Re: Site Plan Application for 873 Holding Company LLC
Restaurant with Accessory Brewing Operations and Tap Room
Premises: 873 North Broadway, North Castle, NY 10603 (122.12-4-27)

November 21, 2021

Mr. Christopher Carthy, Chairman, and Members of the Town of North Castle Planning Board
Town of North Castle, 15 Bedford Road, Armonk, NY 10504
Re: Site Plan Application, 873 N BROADWAY [2021-037]

We have reviewed Mr. Galante's memorandum dated November 4, 2021 and offer the following responses and are submitting additional data and materials with regard to the above matter:

Summary of ITE Quality Restaurant Parking Data Based on Seats

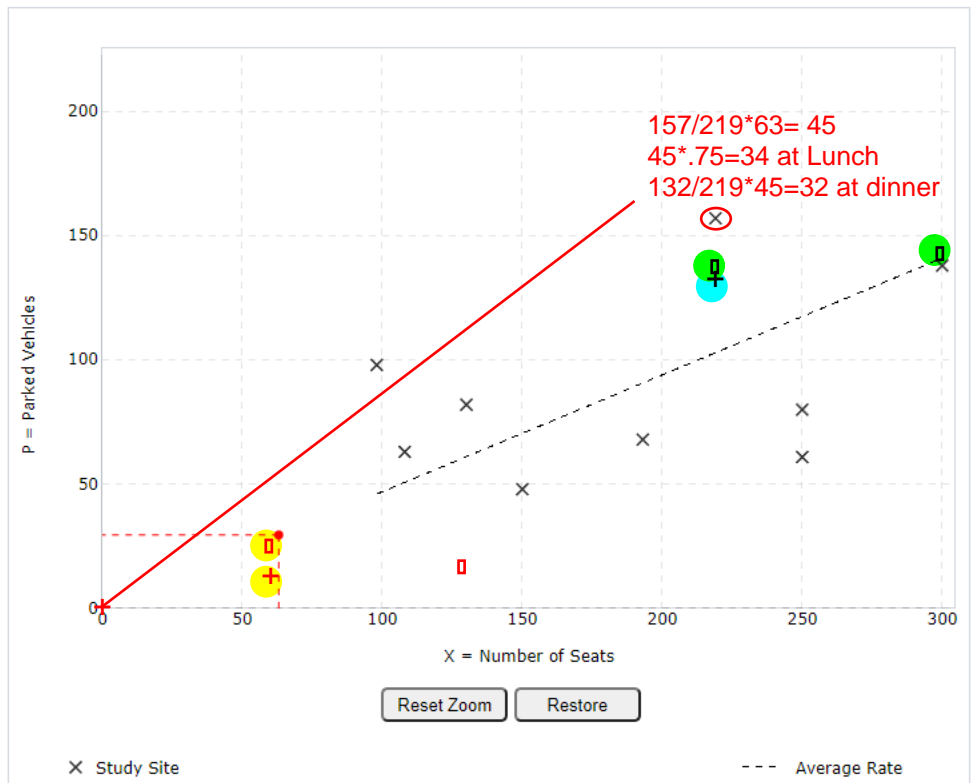
- The 54-parked-vehicle number suggested by Mr. Galante is based on the 85th percentile value of 0.86 parked vehicles per seat listed by the ITE in its publication (see attached). Of the 15 sources from which data was gathered in the ITE report, only 1 restaurant¹ had an observed parking demand ratio greater than 0.72 parked vehicles per seat. This value suggests that such data is atypical in that only one 63-seat restaurant would have more than 45 cars parked at any time (14/15 or approximately the 93rd percentile).
- If 6 of the 54 vehicles parked at a 63-seat restaurant belonged to staff, and diners traveled two per vehicle in the remaining 48 cars during the busiest period, that would mean there would be 96 people at the 63-seat establishment. In such situation, there would be nowhere in the proposed establishment to accommodate the additional 33 people.

As stated above, we agree with Mr. Galante that a 63-seat restaurant could have more than 28 parked cars at the busiest hours. However, a closer look at the data indicates that, at most, a 63-seat restaurant would generate just 45 parked vehicles (based on the highest of all but one of the 15 datapoints).

Friday parking at the two data sources that are common with Saturday (219 seats and 300 seats) was 14% higher and 4% lower than on Saturday, suggesting (though data is limited) that Parking at quality restaurants on Friday's is 5% (average) higher than on Saturdays.

Friday has the most data sources. Where there are common data sources, Friday parking is higher than Saturday, Saturday parking is higher than Mon-Thu and Friday parking is Higher than Mon-Thu parking, Suggesting that the Friday Parking Average is the best predictor of Average peak parking demand.
